HOLDOVER

Revised

SAWYER SUBDIVISION

SAWYER SUBDIVISION

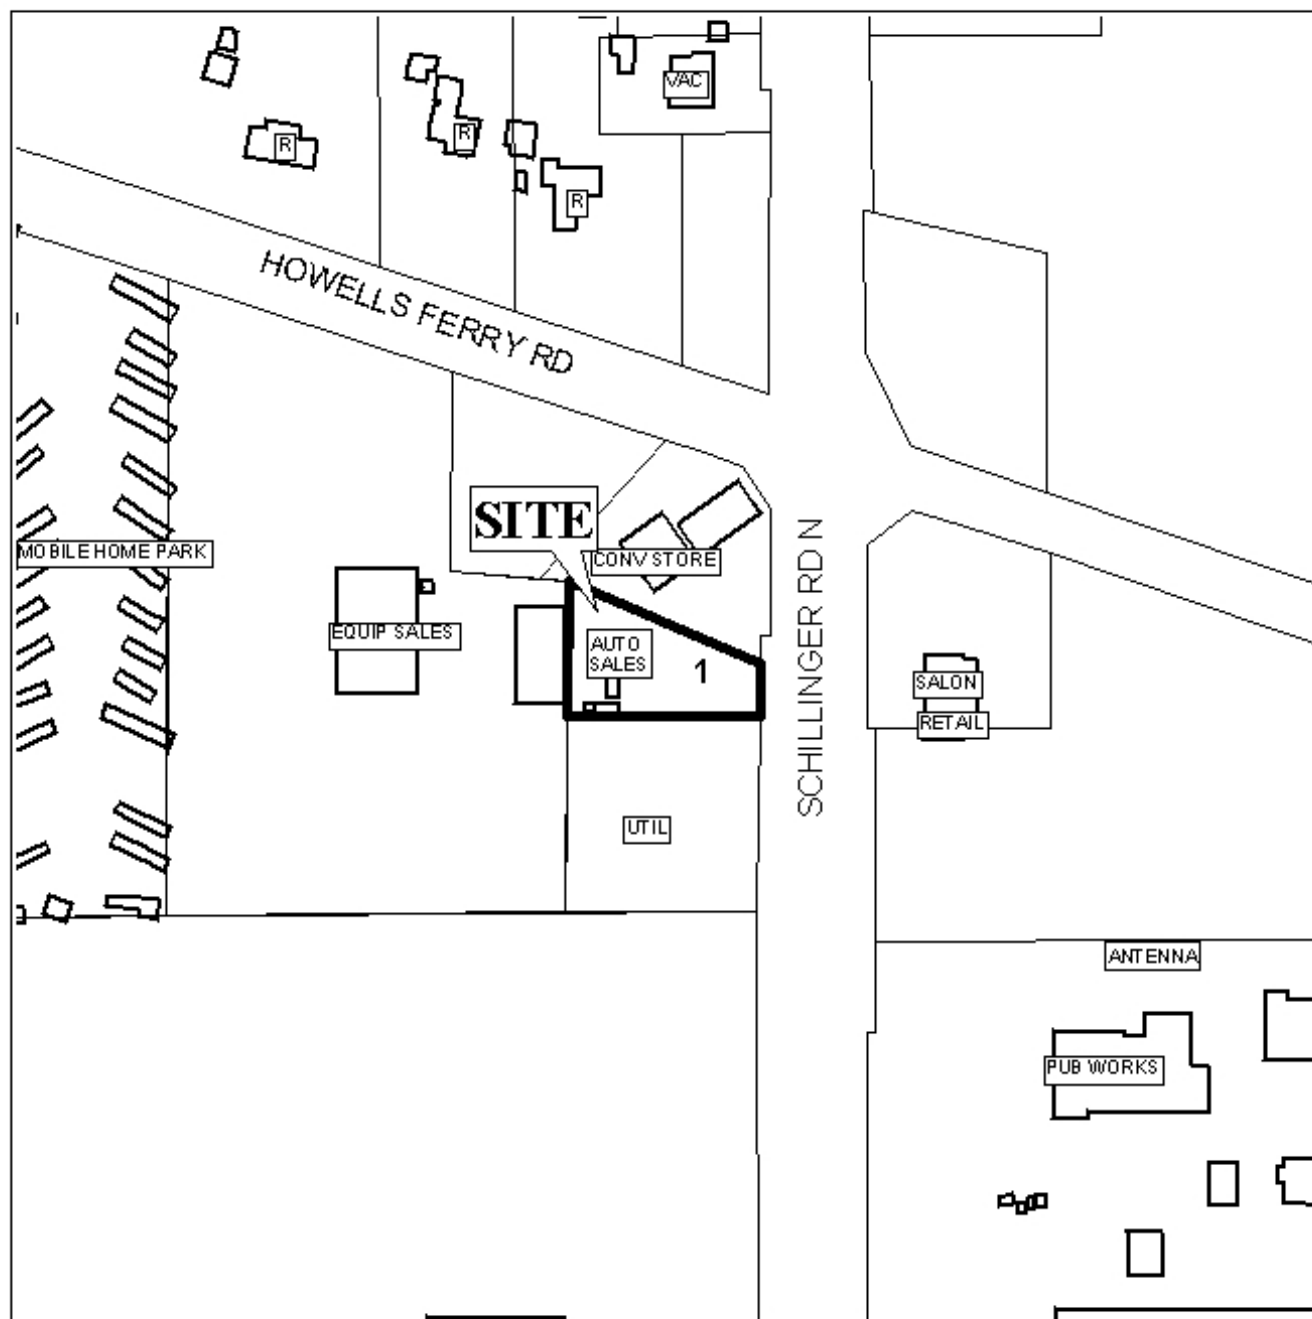
Engineering Comments: Must comply with the Mobile County Flood Damage Prevention Ordinance.

The purpose of the application is the creation of a one-lot subdivision from a metes and bounds parcel. However, the subject parcel is actually part of an existing lot of record; from a subdivision approved in 1988 (McInnis Subdivision, with subject parcel being part of "Lot 1") and recorded. Thus the parcel in its proposed form is incomplete and cannot be documented prior to 1984, and the application should include the entire lot of record.

Whether the site meets the minimum requirements of the Subdivision Regulations cannot be addressed until the entire site is submitted for review.

As the plat does not include the entire lot involved in the subdivision, the site cannot be documented in its present configuration prior to 1984, no revisions have been received, and no additional time has been requested, the plat is recommended for denial.

Submitted documentation shows that the site was sold multiple times before the present owners purchased it. In previous cases where applicants have documented multiple prior sales of an illegally subdivided parcel, the Planning Commission has accepted the incomplete parcel for subdivision. It should also be noted that the naming of this subdivision should follow the accepted standard for naming by including a reference to the original subdivision, for example: "Sawyer Subdivision, a resubdivision of a portion of Lot 1, McInnis Subdivision." As the site otherwise meets the minimum standards of the Subdivision Regulations, the application is recommended for Tentative Approval subject to the following conditions: 1) the depiction of the 25' building setback line from Schillinger Road; 2) the placement of a note on the final plat stating that the site is limited to the existing curb cut, and; 3) renaming of the subdivision to follow generally accepted naming standards.

Based on the preceding, the application is recommended for holdover to allow the applicant to submit revised plats including the entire lot of record, and any necessary fees and information for notifications.
